Safety Evaluation Report

related to the renewal of the
operating license for the
University of New Mexico Research Reactor

Docket No. 50-252

March 1987

Figure 4.1 AGN-201M core tank and contents

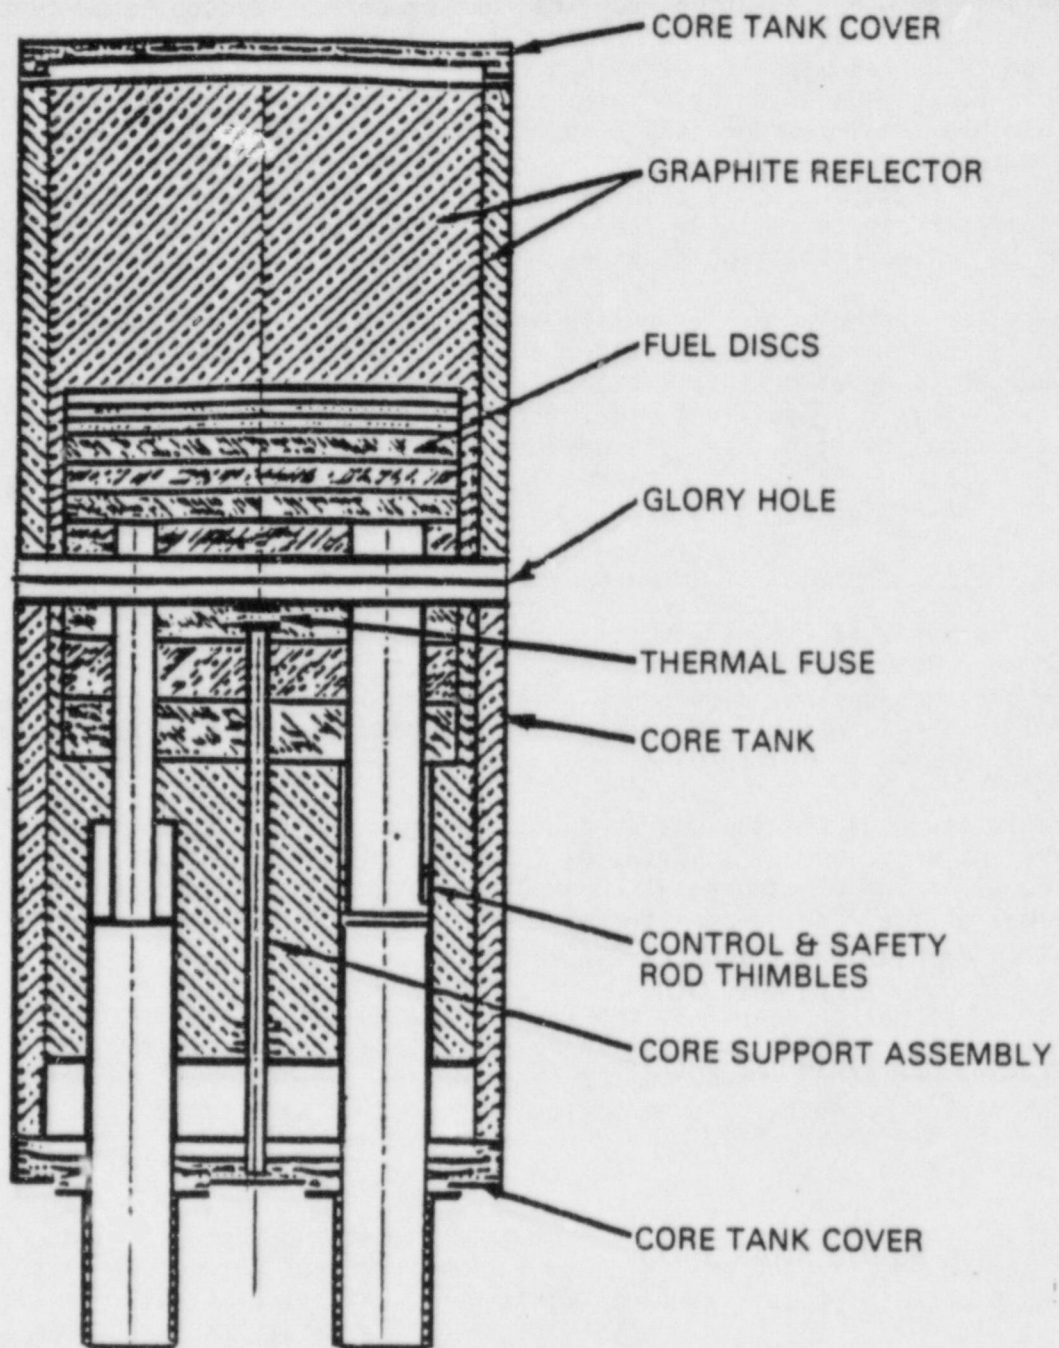
The cylindrical reactor core (Figure 4.1), which is 25.6 cm in diameter by 24 cm high, consists of nine separate polyethylene disks that contain particles of UO_2 enriched to <20 percent U-235. The core is contained in a gas-tight aluminum cylindrical tank (32.2 cm diameter and 76 cm high). A 2.54 cm diameter tube (glory hole) passes through the center of the core to allow experimental access. The total fuel loading is 667 g of U-235. A basic safety design feature of the reactor core is the core polystyrene fuse which supports the bottom three fuel disks of the core. The fuse contains a fuel density twice that of the fuel disks so that during operation, more fission heat is generated in the fuse than in the remainder of the core. Thus, any reactivity transient would heat the fuse twice as fast as the core. Should the temperature of the fuse reach 120°C , the polystyrene fuse will melt, allowing the three bottom disks to separate from the remaining disks and thus neutronically shut down the reactor.

As shown in Figure 4.1, the reflector consists of graphite surrounding the core. It is 20 cm thick with a density of 1.75 g/cm^3 . A portion of the graphite is in the aluminum core tank and the remainder is outside. For experimental purposes there are four access holes, 10 cm in diameter, that pass through the graphite to the exterior of the water tank.

Figure 4.2 Control rod

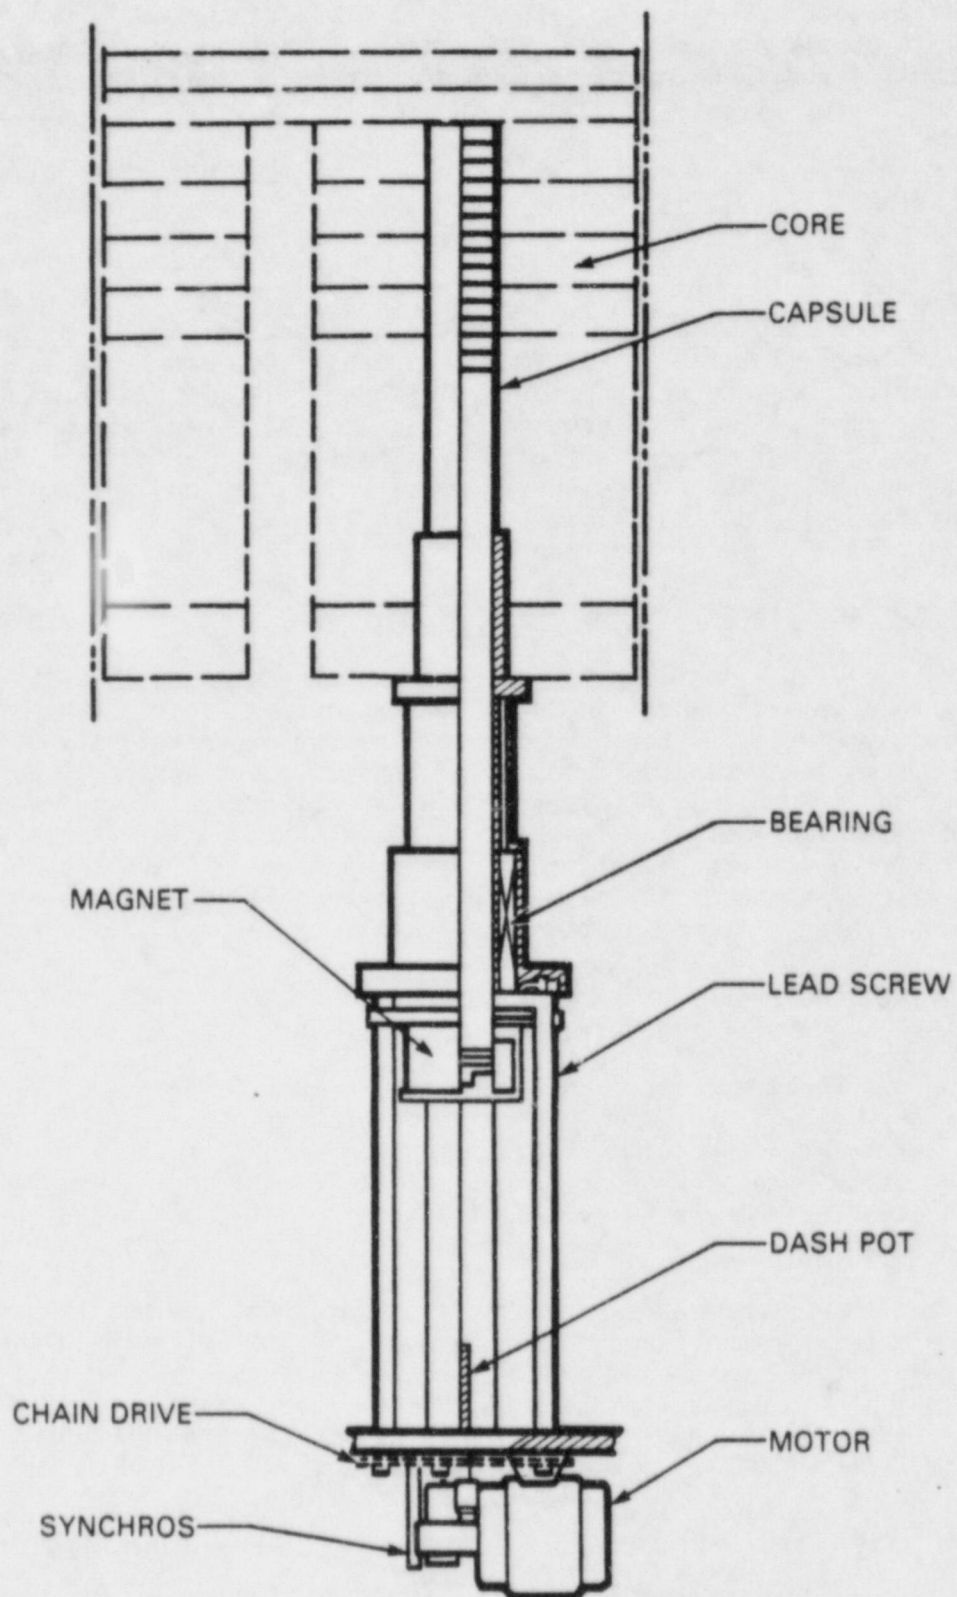
The safety rods and the coarse control rod are individually magnetically coupled to a carriage and compress a spring as they are driven into the core. Thus, the removal of the electromagnet current deactivates the magnets and results in withdrawal of the rods by gravity, with an assist from the compressed springs. Figure 4.2 shows the control rod mechanism.
